Re: Jerome Professional Parkway Phase 2 Comment

A condition of the **Jerome Professional Parkway, Phase 2 - Preliminary Plat** approval was a 10' Utility Easement flanking the right-of-way along Sycamore Trace to US Hwy 42.

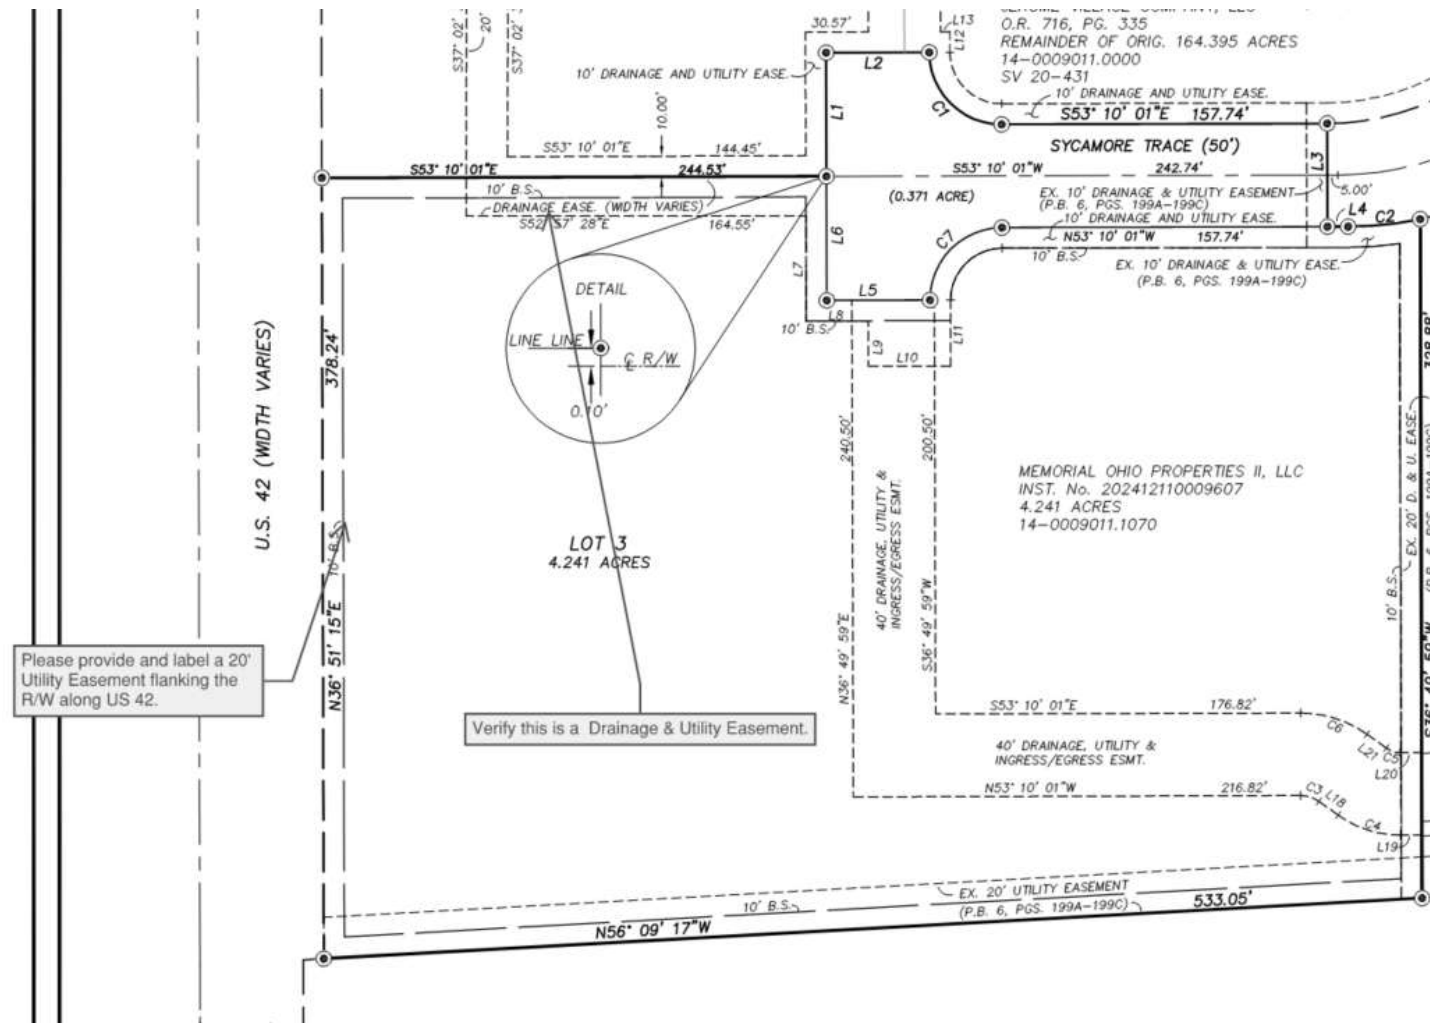
You are correct that the existing easements are sufficient. I would like to ask that the Drainage Easement off the end of Sycamore Trace be changed to a Drainage & Utility Easement. See the image below with our comments for this plat.
